### BROADMOOR SAFE ROUTES TO SCHOOL PEDESTRIAN IMPROVEMENTS PROJECT

### PROJECT FILE NO. E5050

#### **ADDENDUM NO. 2**

9 (REV) FOR REDUCED PLANS ORIGINAL SCALE IS IN INCHES SHEET 9 OF 18

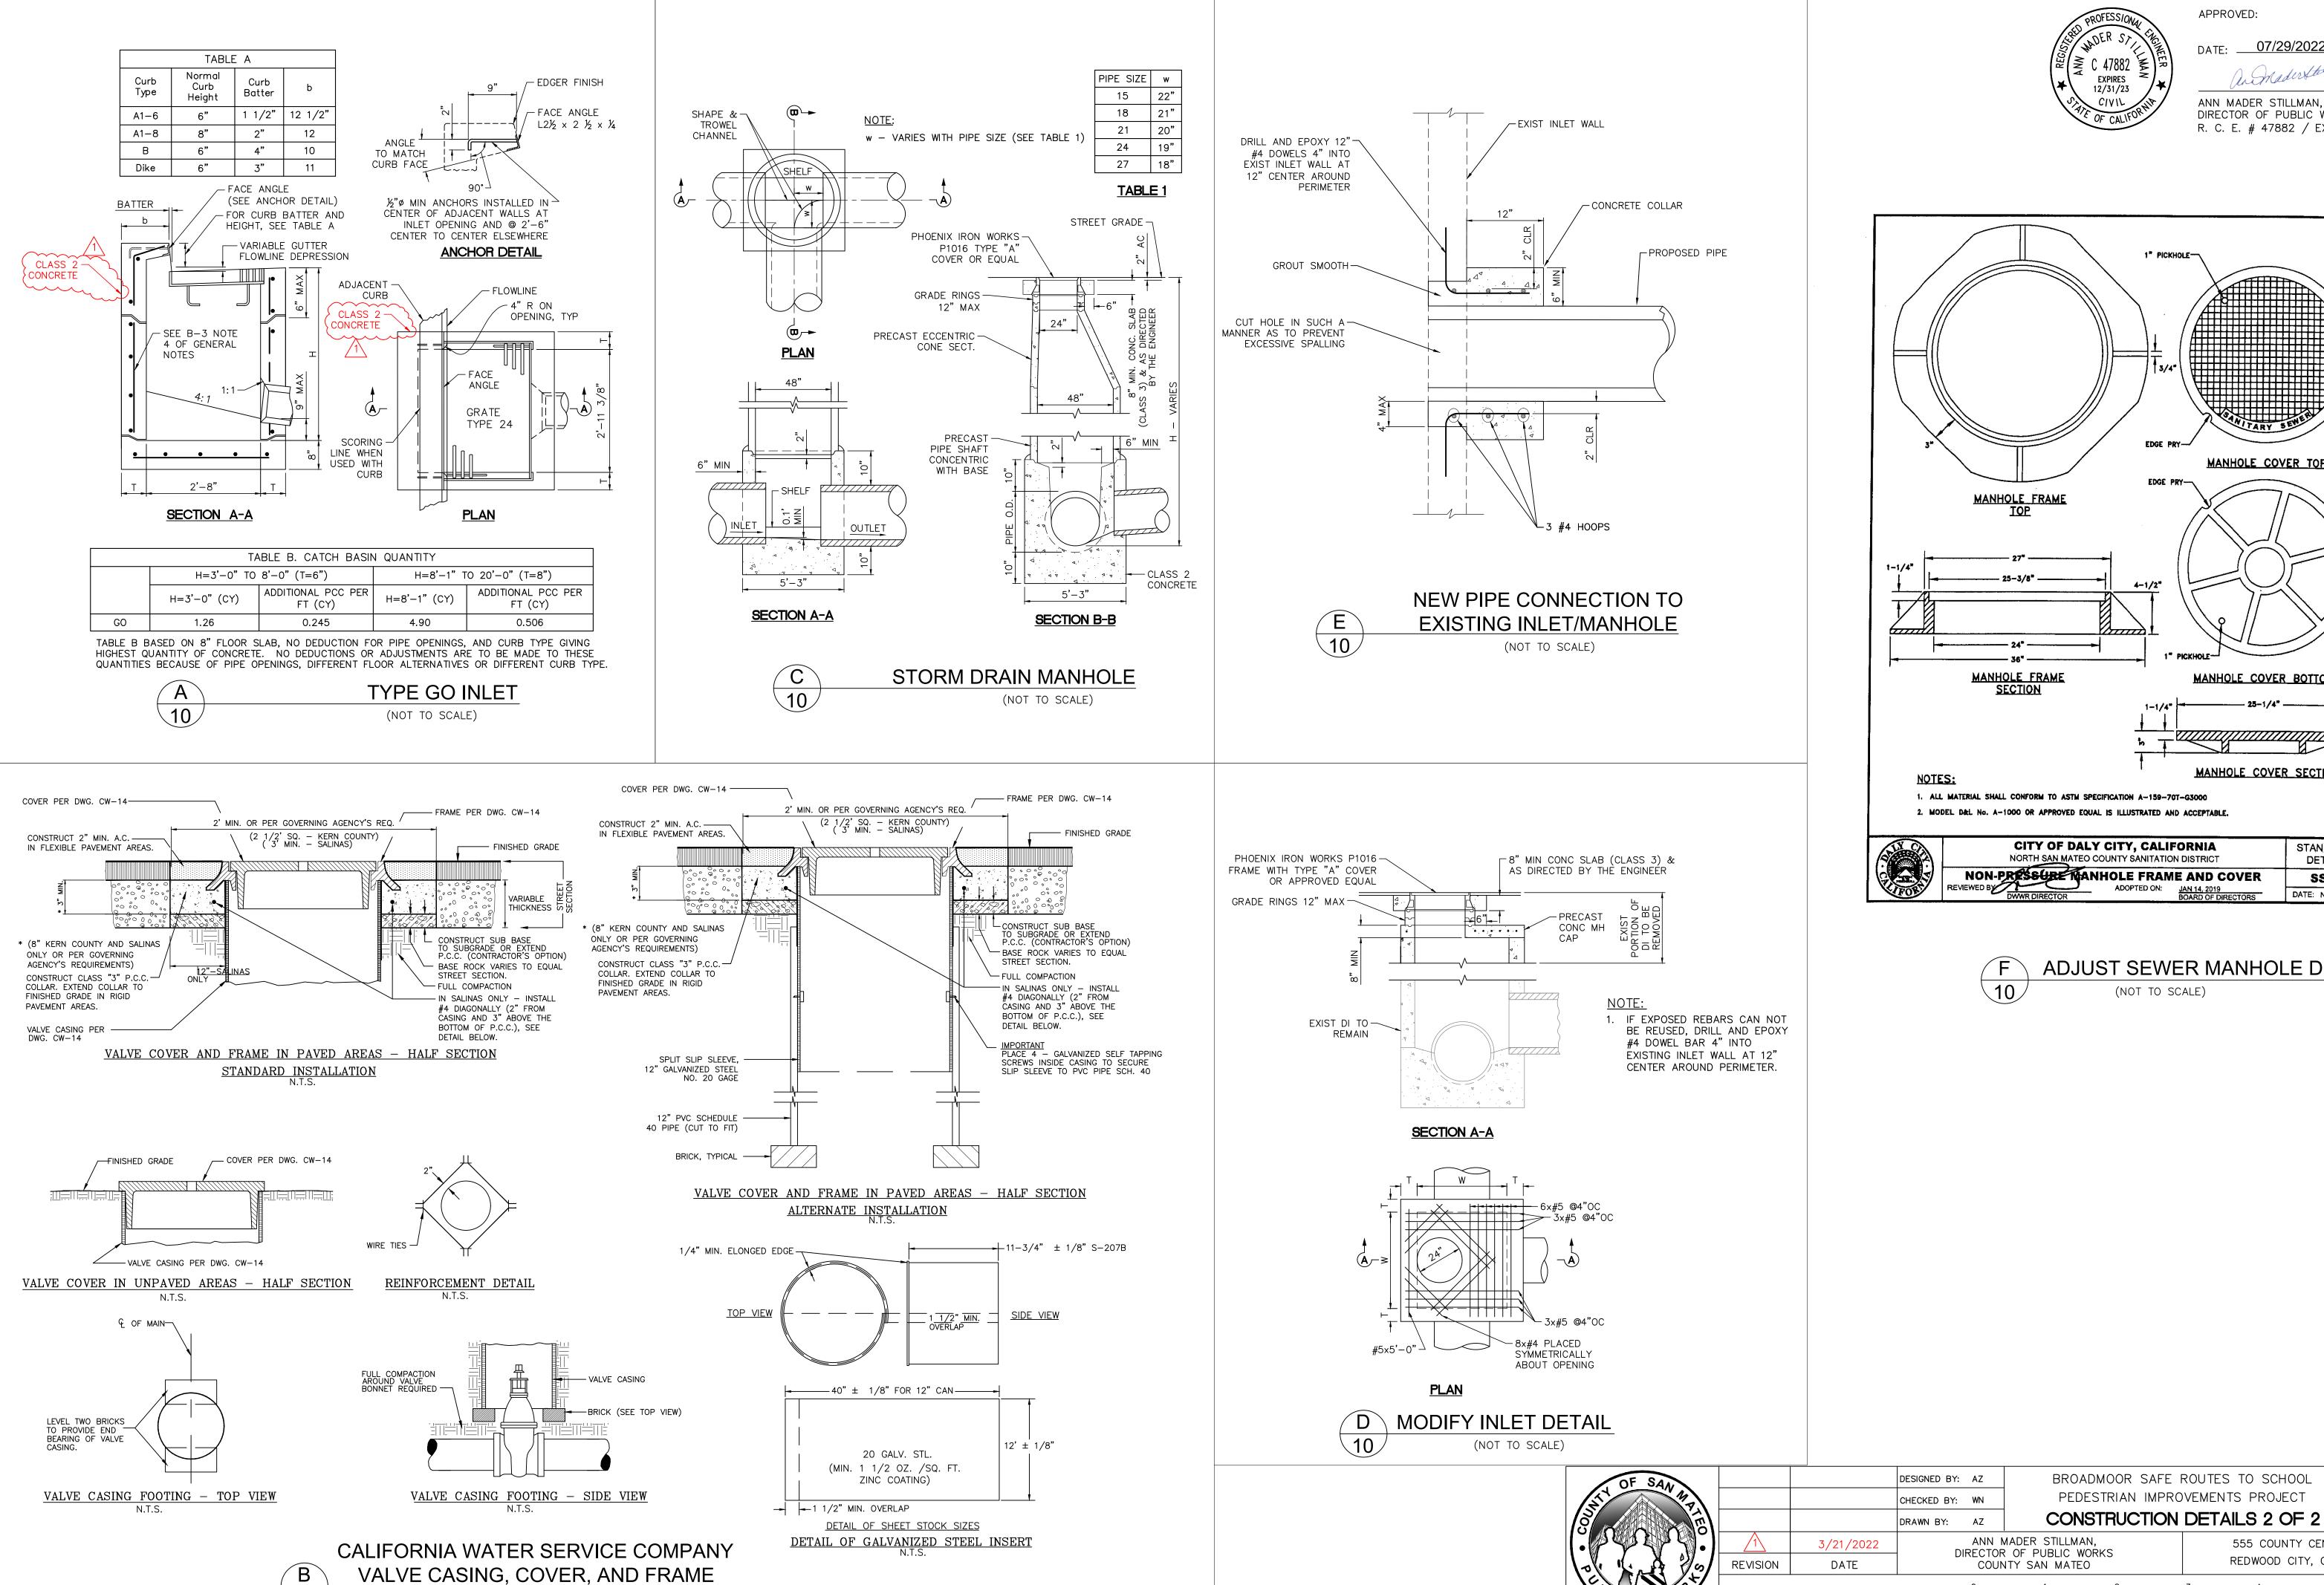
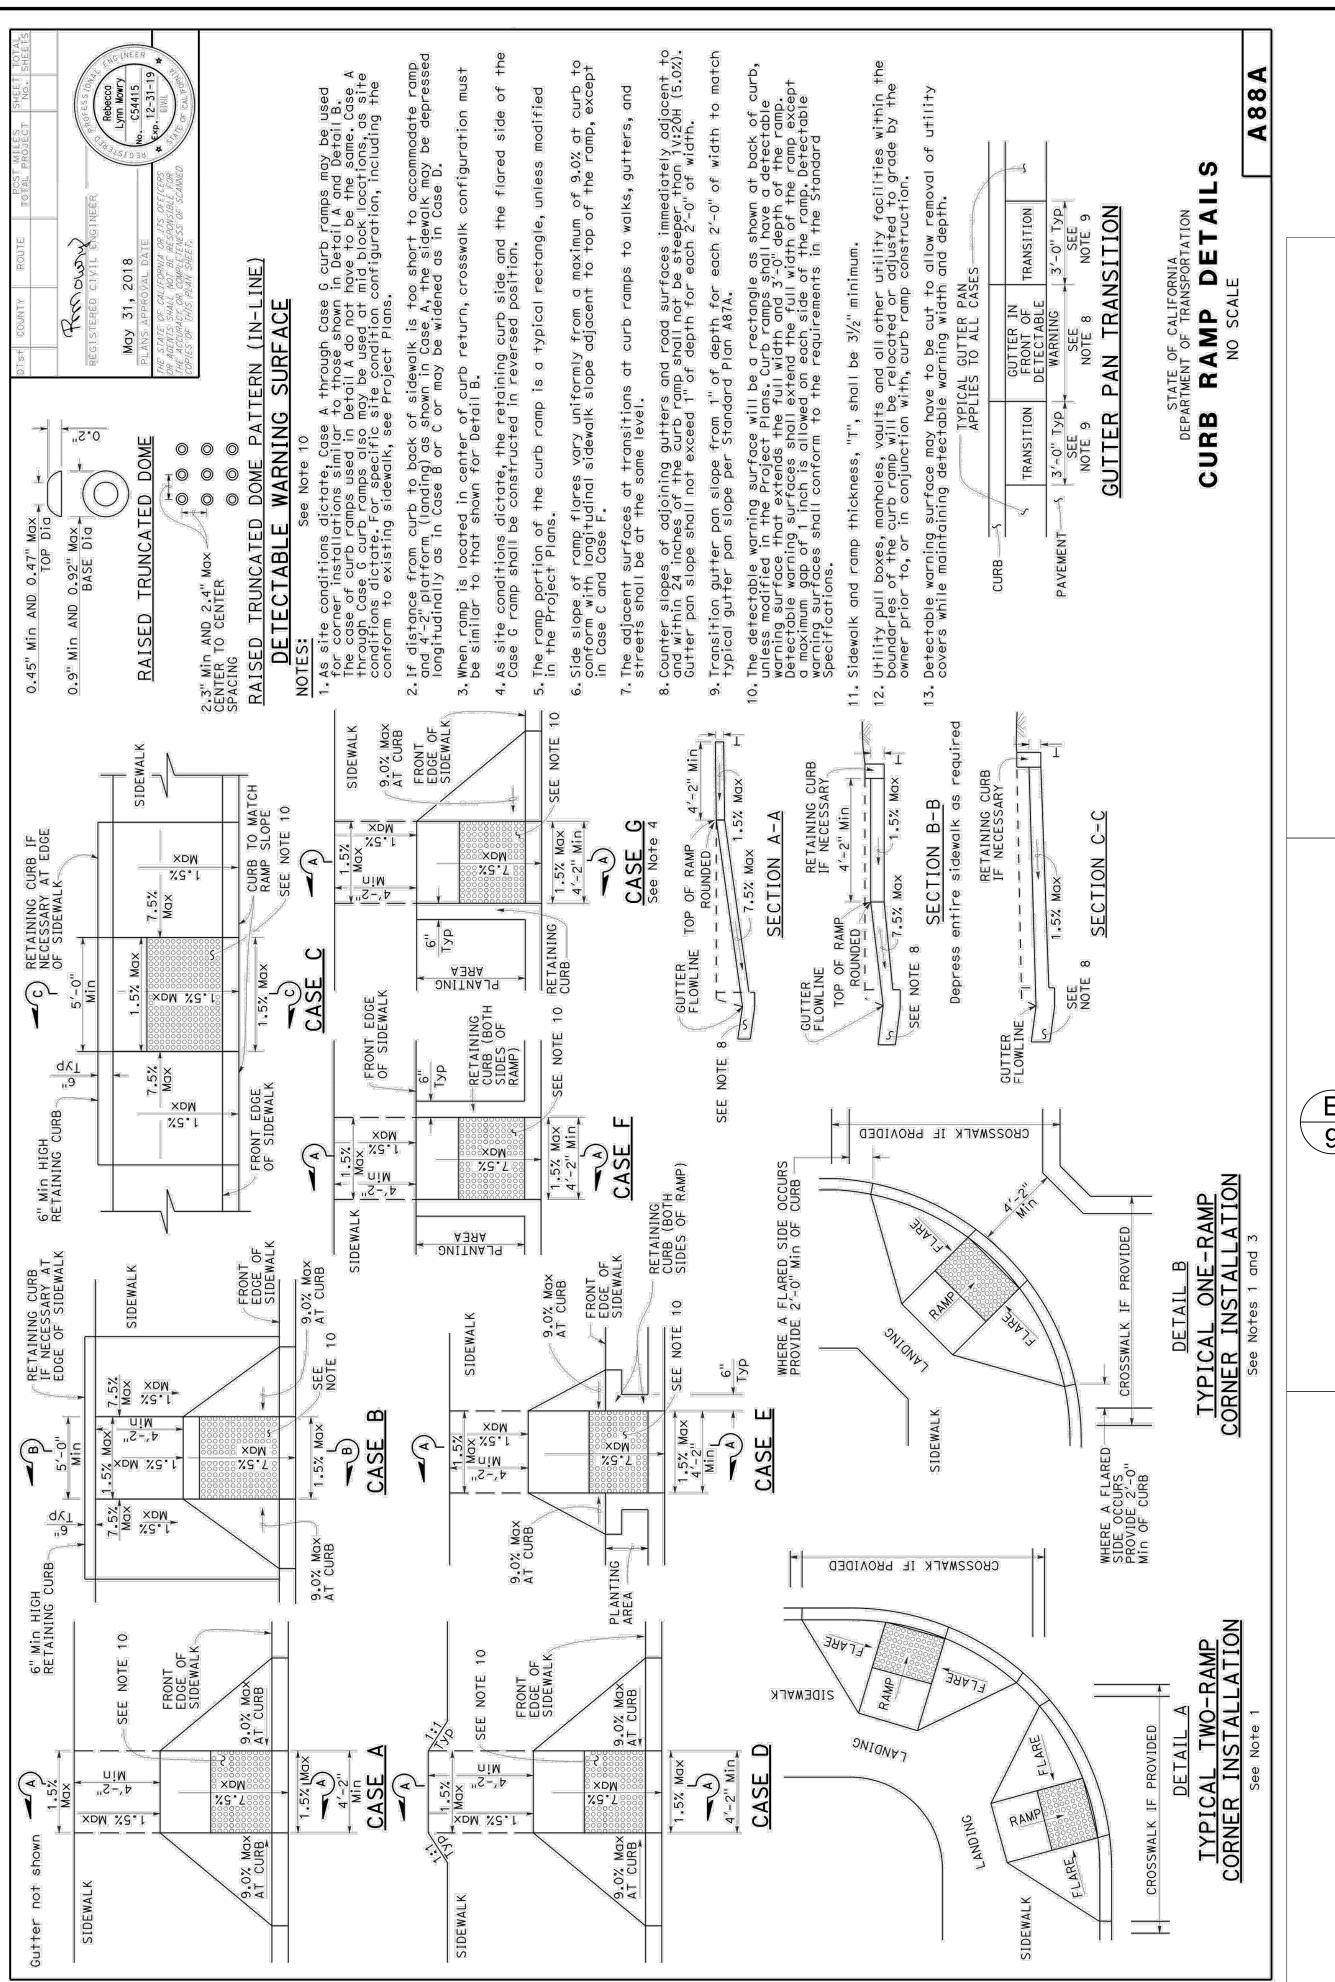
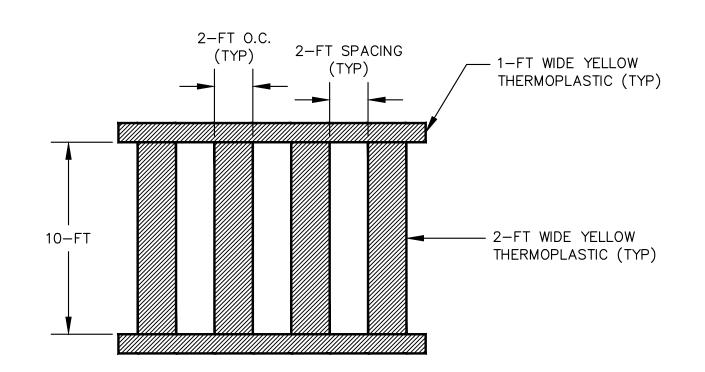
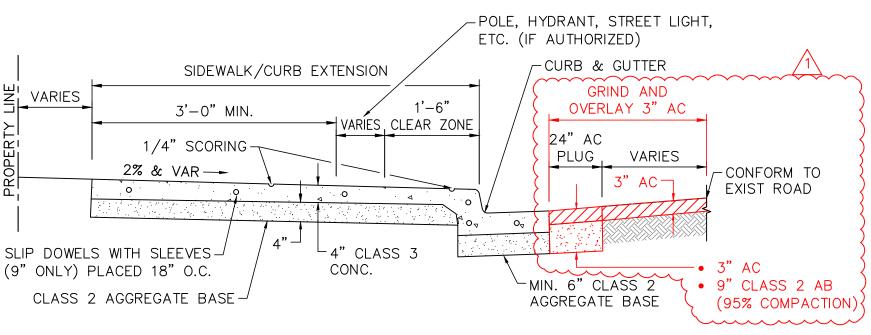
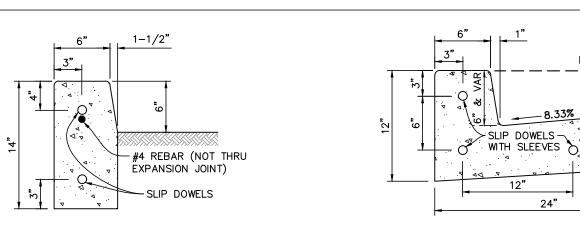
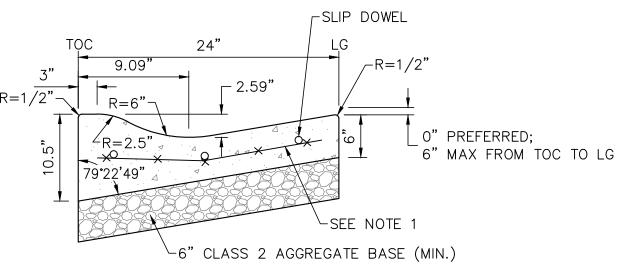
1. Detail D on Plan Sheet 9 has been updated. Sheet 9 shall be replaced in the Project Plans:

### Replace plan sheet 9 with plan sheet 9 (REV).

10 (REV) SHEET 10 OF 18

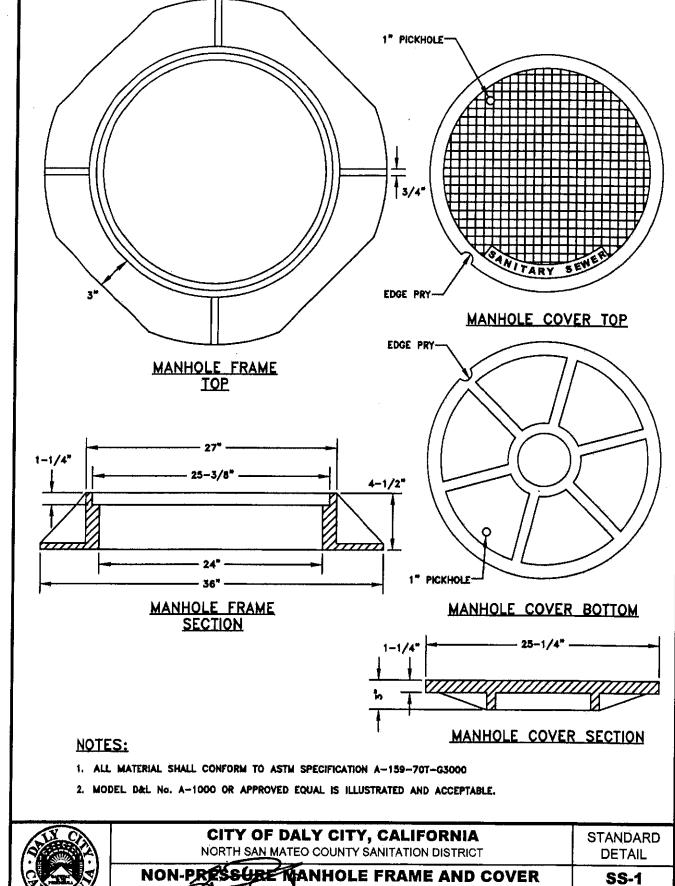
2. Detail A on Plan Sheet 10 has been updated. Sheet 10 shall be replaced in the Project Plans:

### Replace plan sheet 10 with plan sheet 10 (REV).
